APPLICATION NO.	FILING DATE	FIRST NAMED INVENTOR	ATTORNEY DOCKET NO.	CONFIRMATION NO.
10/501,619	05/25/2005	Joachim Christ	37742-97114	2228
23644 RAPNES & TI	7590 08/21/2007 HORNBURG LLP	EXAMINER		
P.O. BOX 2786			NGUYEN, XUAN LAN T	
CHICAGO, IL	60690-2786		ART UNIT	PAPER NUMBER
			3683	
			MAIL DATE	DELIVERY MODE
		·	08/21/2007	PAPER

Application No.	Applicant(s)				
	10/501,619	CHRIST, JOACHIM				
Office Action Summary	Examiner	Art Unit				
	Lan Nguyen	3683				
The MAILING DATE of this communication app Period for Reply	pears on the cover sheet with the c	correspondence address				
A SHORTENED STATUTORY PERIOD FOR REPL WHICHEVER IS LONGER, FROM THE MAILING D - Extensions of time may be available under the provisions of 37 CFR 1.1 after SIX (6) MONTHS from the mailing date of this communication. - If NO period for reply is specified above, the maximum statutory period - Failure to reply within the set or extended period for reply will, by statute Any reply received by the Office later than three months after the mailin earned patent term adjustment. See 37 CFR 1.704(b).	ATE OF THIS COMMUNICATION 36(a). In no event, however, may a reply be tin will apply and will expire SIX (6) MON

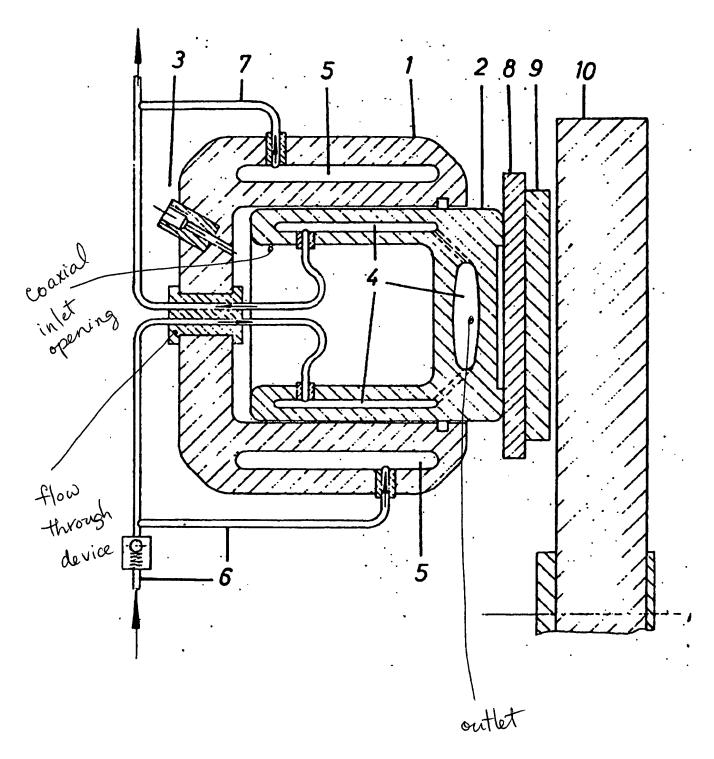
Re: claim 12, Fuchs shows a brake caliper in figure 1, as in the present invention, having a caliper wall, the caliper wall defining a cylinder 1 with at least one axially displaceable, hydraulically actuated piston 2 received in the cylinder, with which a brake pad 8, 9 can be pressed against a brake disc 10, the piston defining a cavity 4 therewithin, with at least one inlet opening for feeding a cooling medium into the cavity, the inlet opening being arranged in the piston spaced away from the brake pad, and at least one outlet opening arranged in the piston adjacent to the brake pad for discharging cooling medium from the cavity to adjacent the brake pad, as marked below, characterized in that a flow through device, as marked below, extends from the caliper wall into the interior space of the piston to allow passage of cooling medium from outside the caliper wall to the cavity, as shown. Fuchs provides examples of the cooling

Re: claim 13, Fuchs shows the flow through device to be integral with the wall of the brake caliper, as shown.

Re: claim 14, Fuchs also shows the piston comprises a hollow cylinder having a pair of face ends, wherein the brake pad 9 is located on one of the face ends and an inlet opening, as marked below, through which the flow-through device extends, is defined on the other face end, the inlet opening being coaxial to the cylinder, as shown below.

Applicant's amendments necessitated the new ground of rejection based on Fuchs in view of Ross, wherein Ross is relied upon for the teaching of air and other liquids to be recognized as well-known art equivalents for their use as cooling media. Applicant also argues that Fuchs does not show the coaxial inlet opening. As marked above, the coaxial inlet opening where the cooling medium comes in the piston is shown to be coaxial with cylinder. Also, as marked above, the outlet is adjacent to the brake pad. As presented, claim 12 does not distinguish itself from the structure of the cooling system of Fuchs.
